ATTACHMENT I

Re: Turkey Point Units 3 and 4
Docket Nos. 50-250 and 50-251
Proposed License Amendment
Revised Technical Specifications

MARKUP OF FINAL DRAFT
OF TECHNICAL SPECIFICATIONS

FIGURE 3.2-1
 AXIAL FLUX DIFFERENCE LIMITS AS A FUNCTION OF
 RATED THERMAL POWER

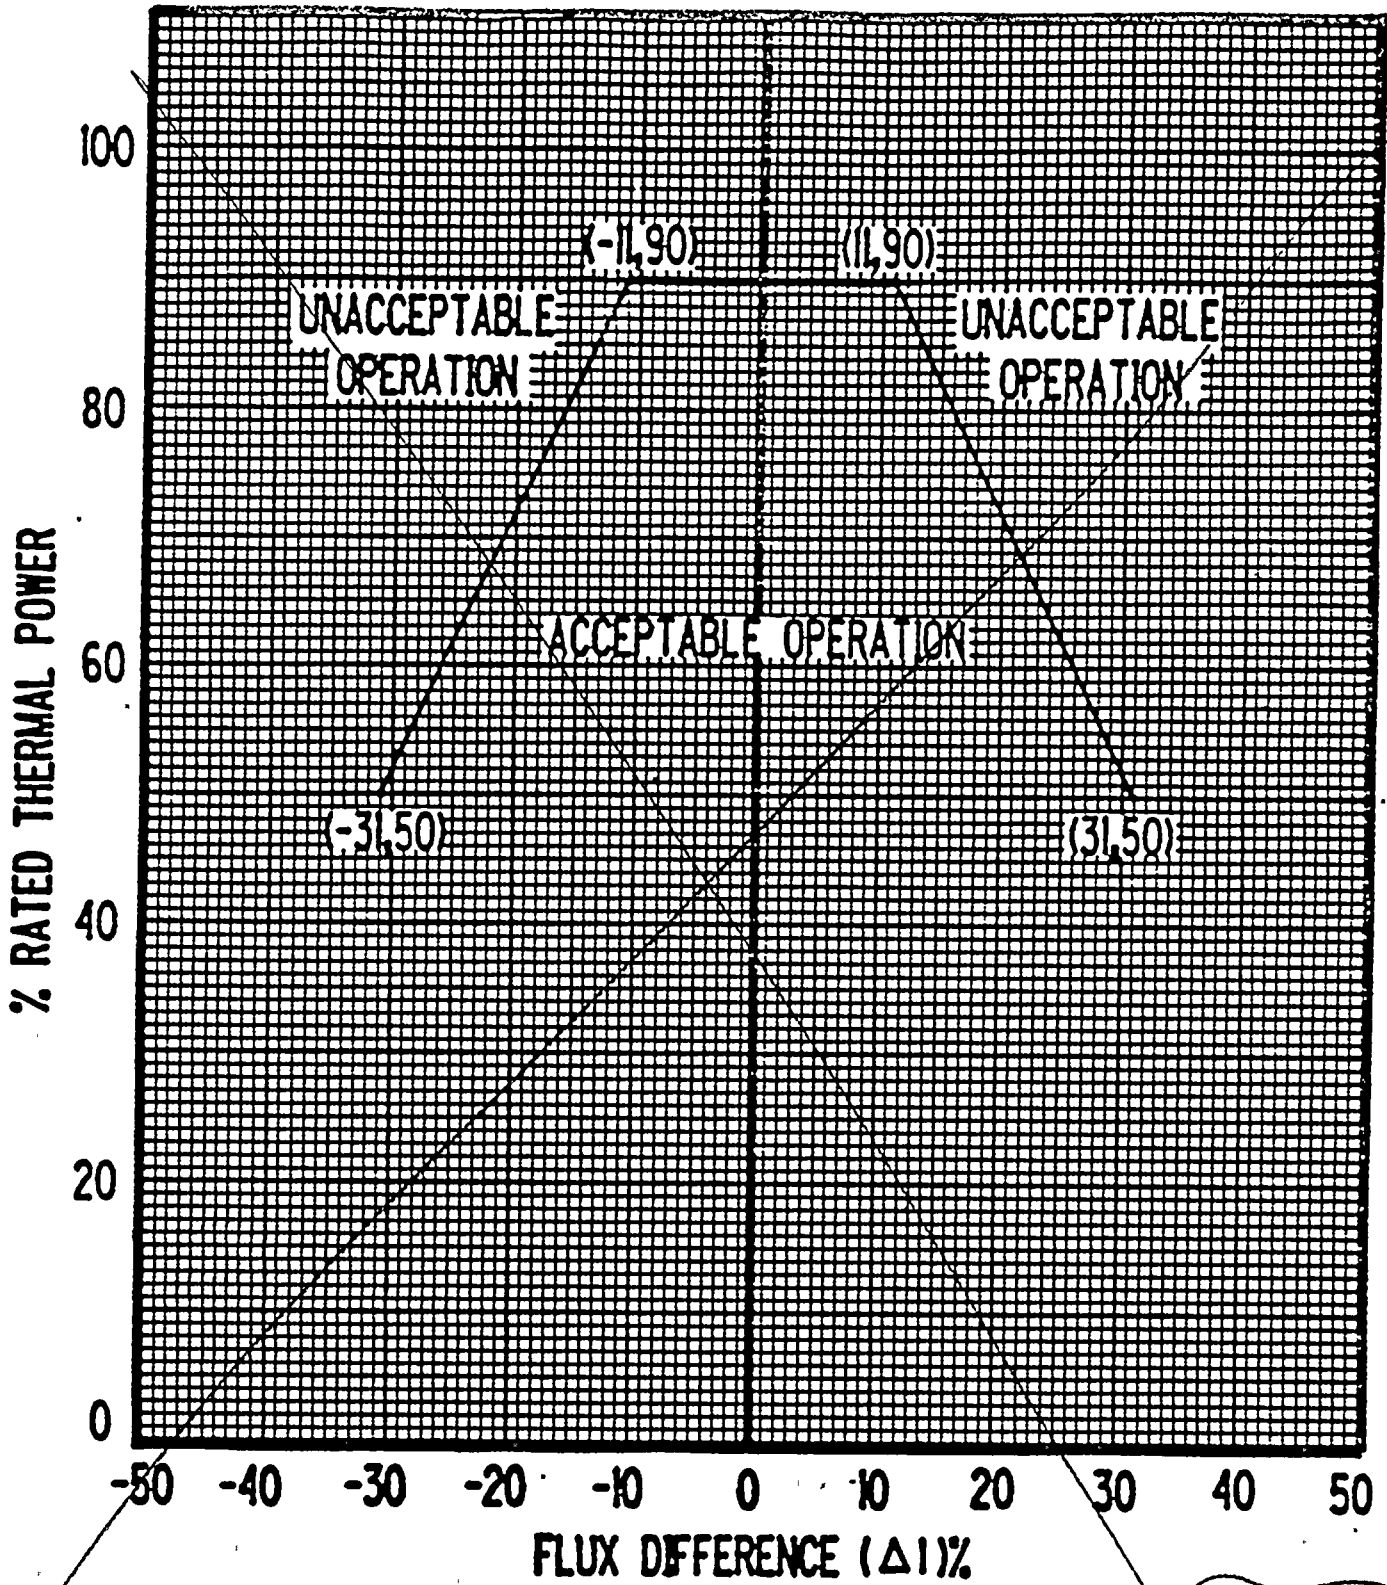
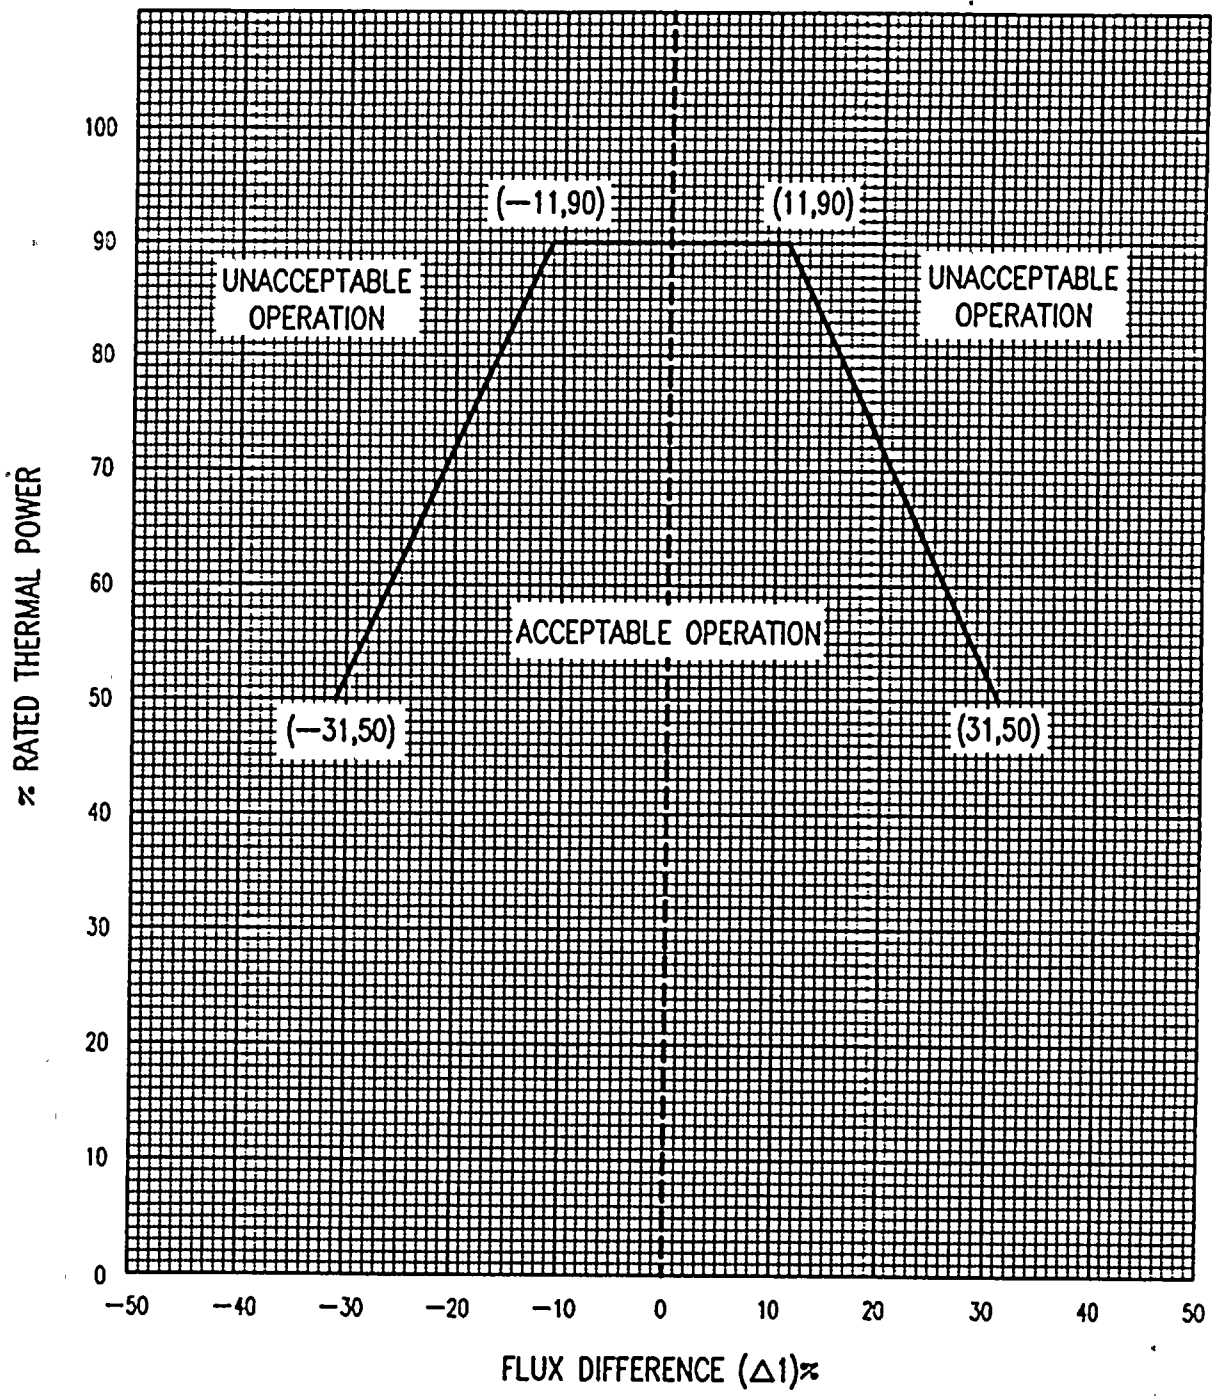
See next page

FIGURE 3.2-2
 $K(Z)$ NORMALIZED $F_0(Z)$ AS A FUNCTION OF CORE HEIGHT

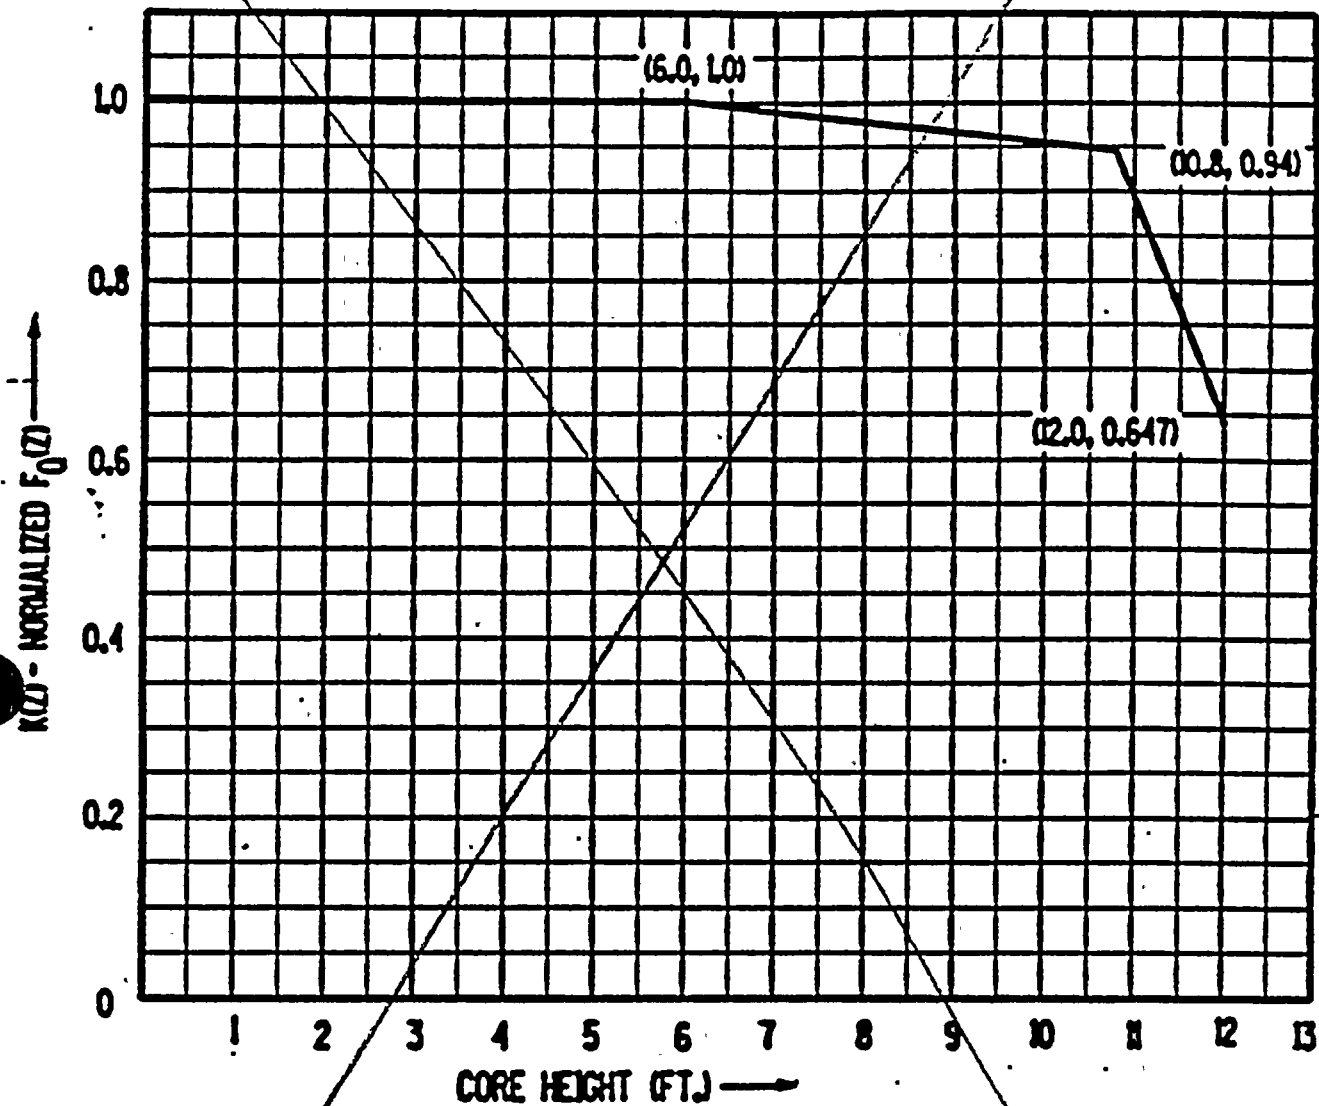
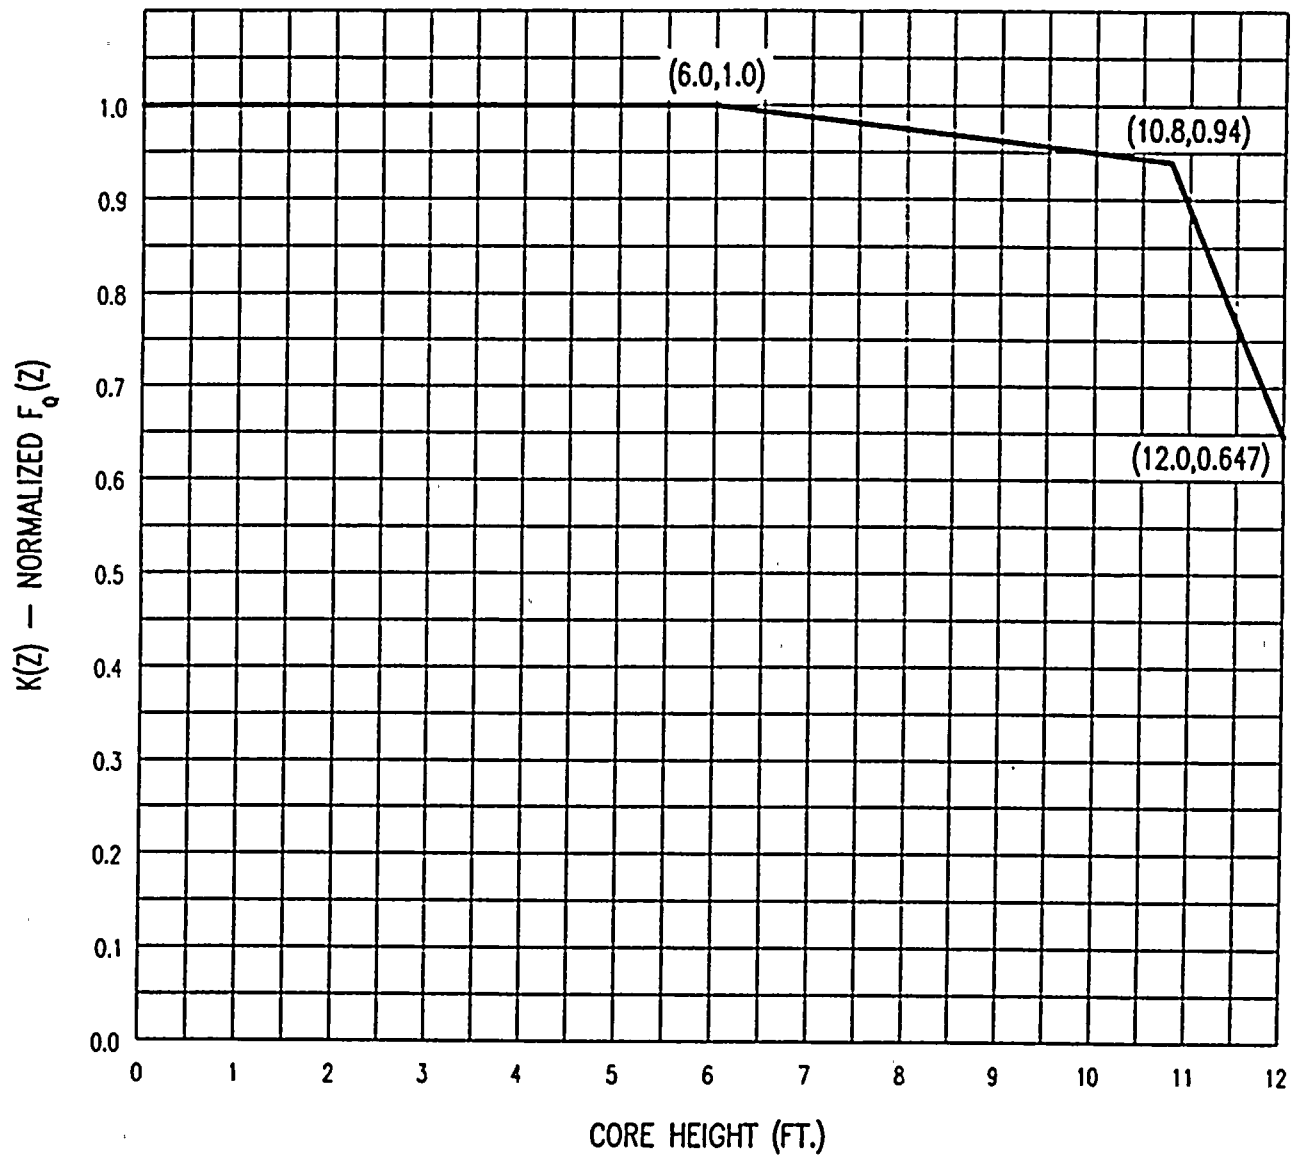
See next page

Figure 3.5-1
RHR Pump Curve

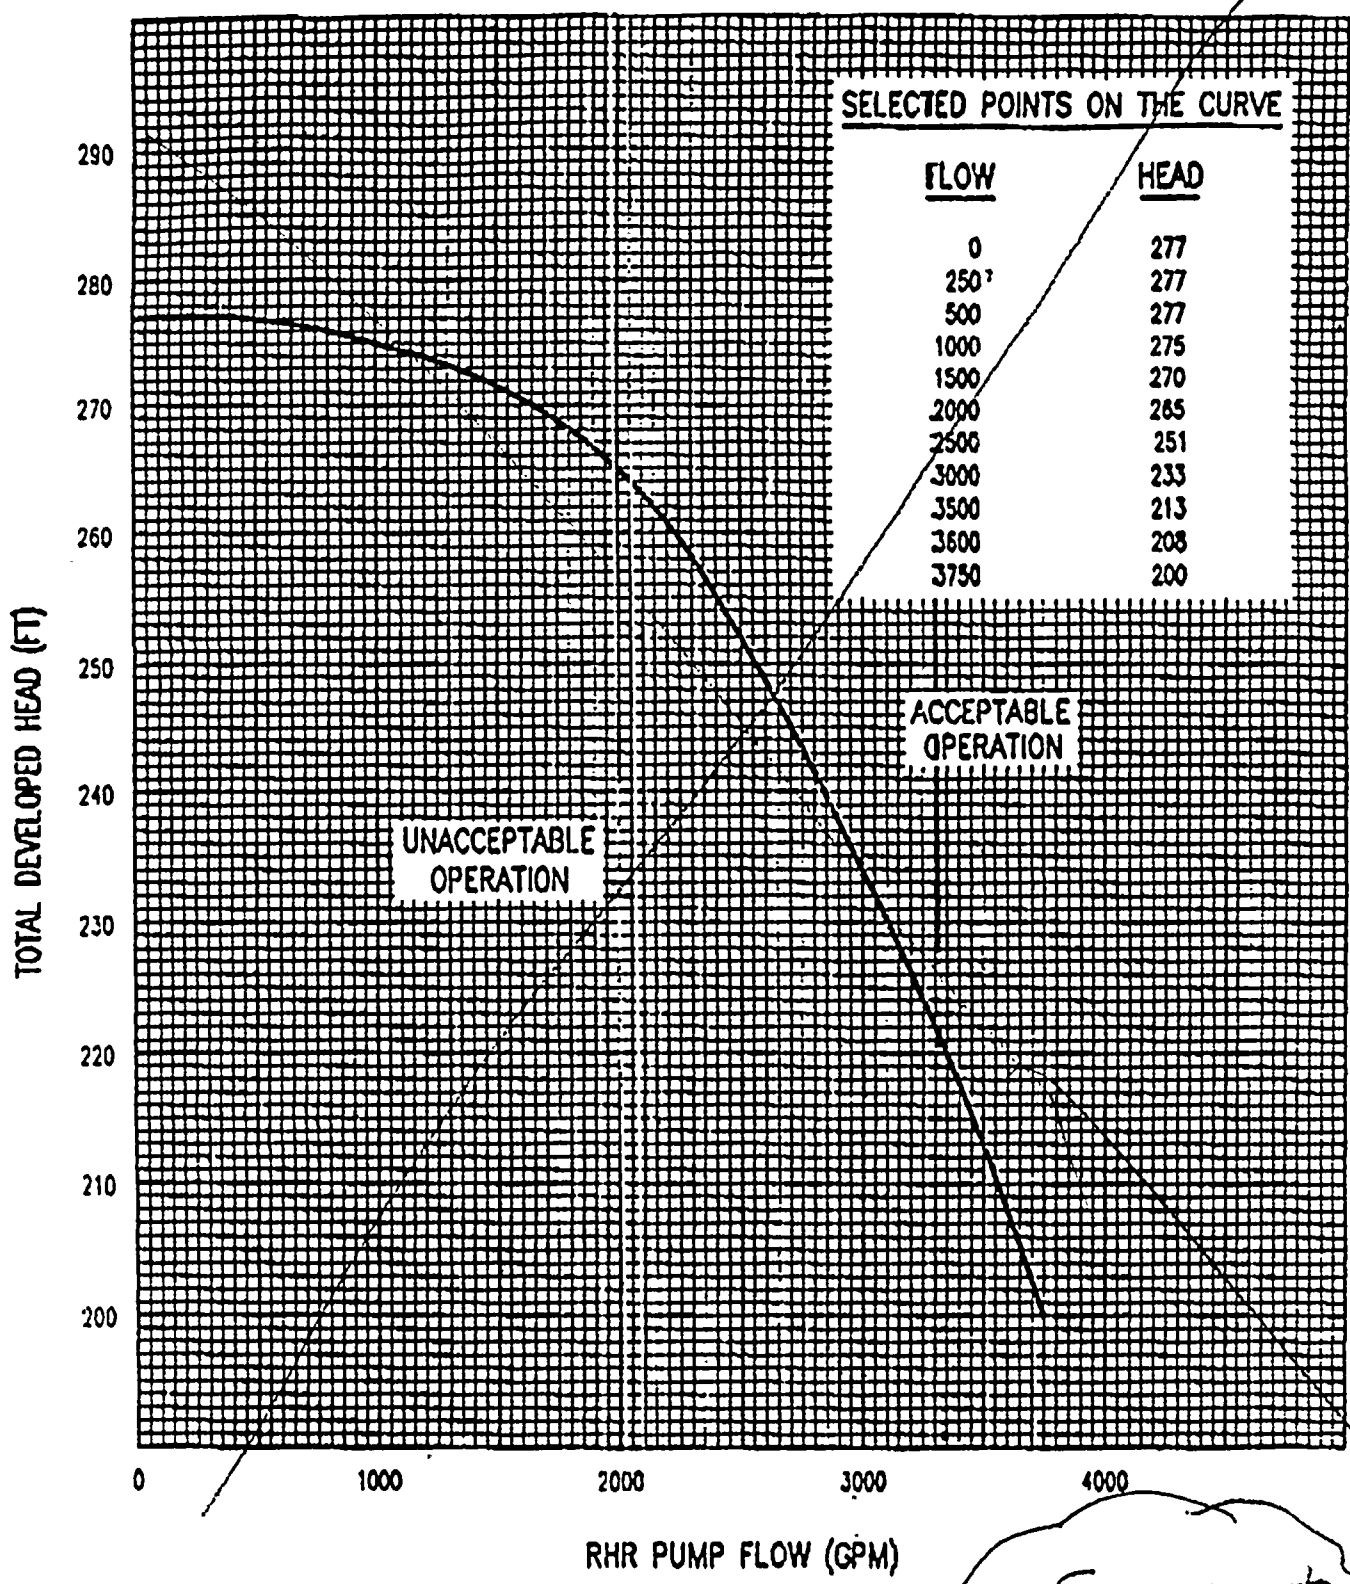
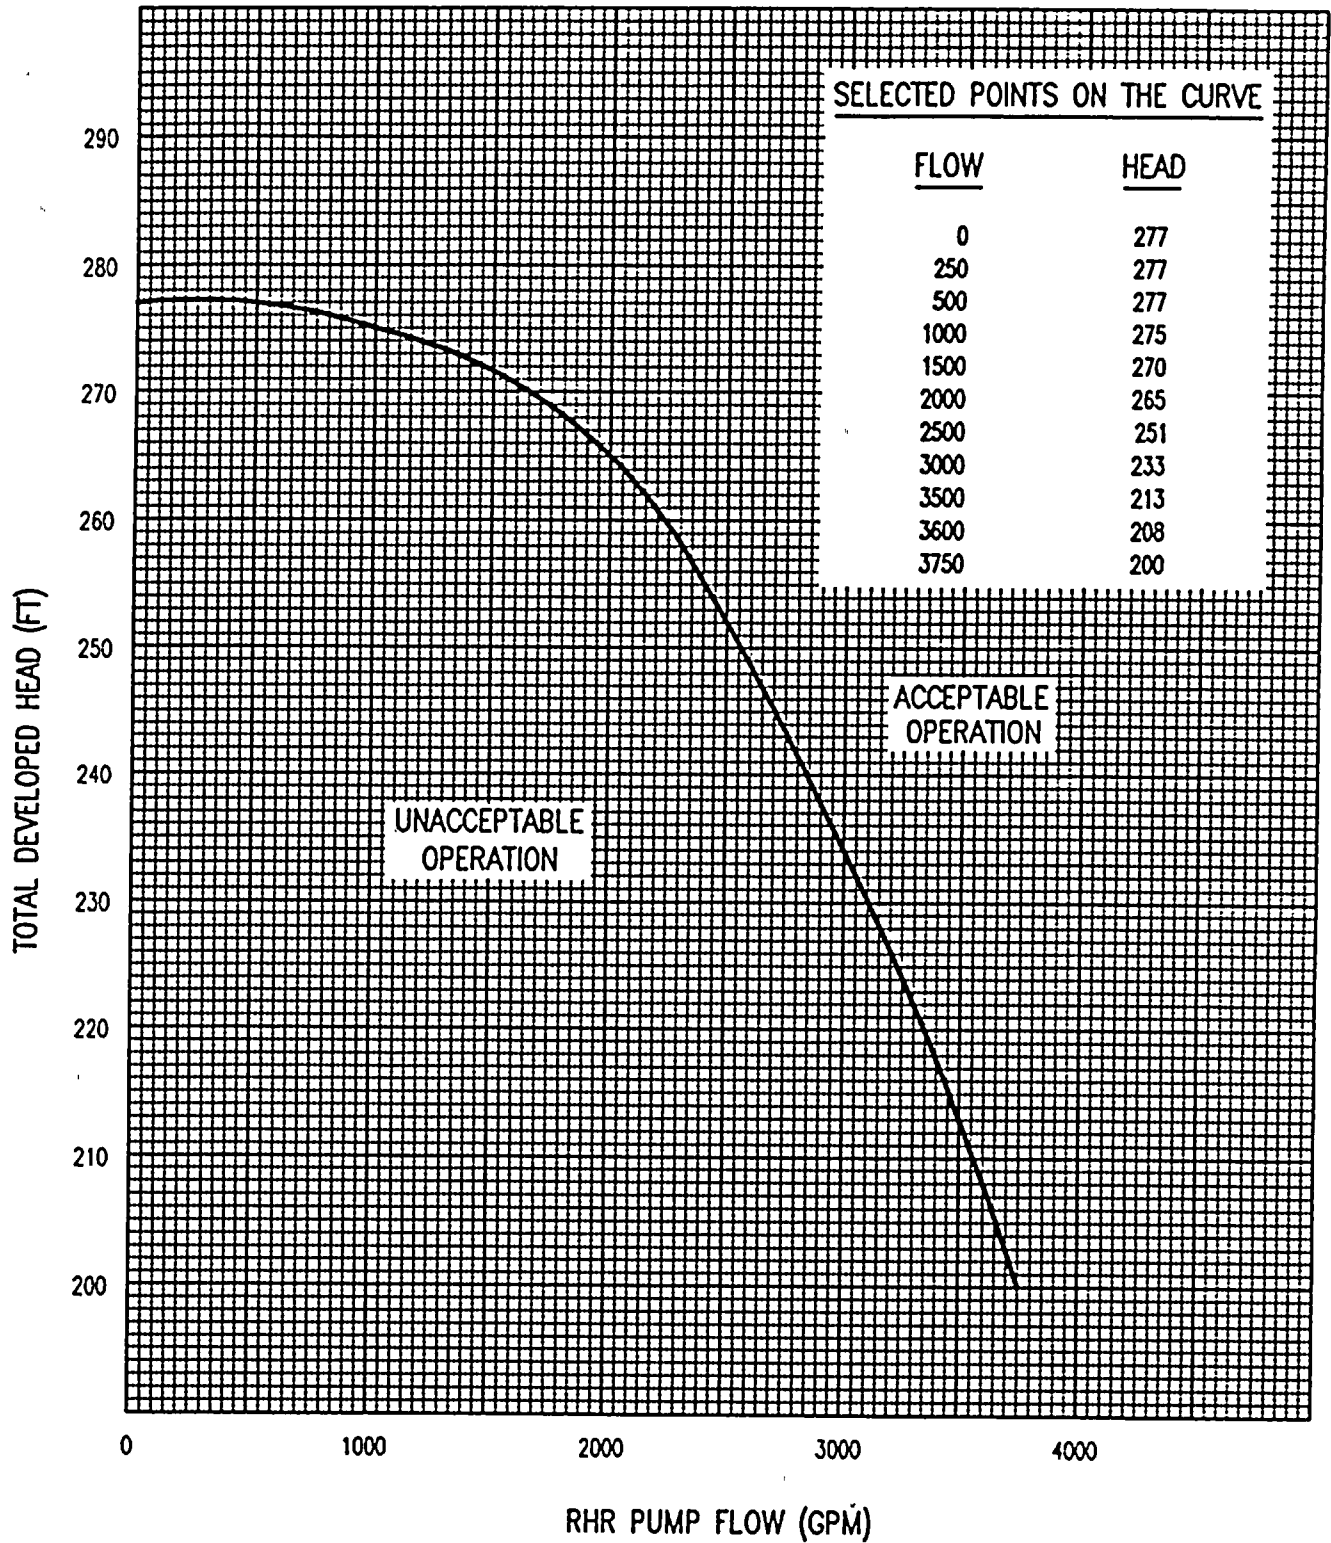
- 1) Verifying that each SI pump develops the indicated differential pressure applicable to the operating conditions ~~in accordance with Figure 3.5-1~~ when tested pursuant to Specification 4.0.5.
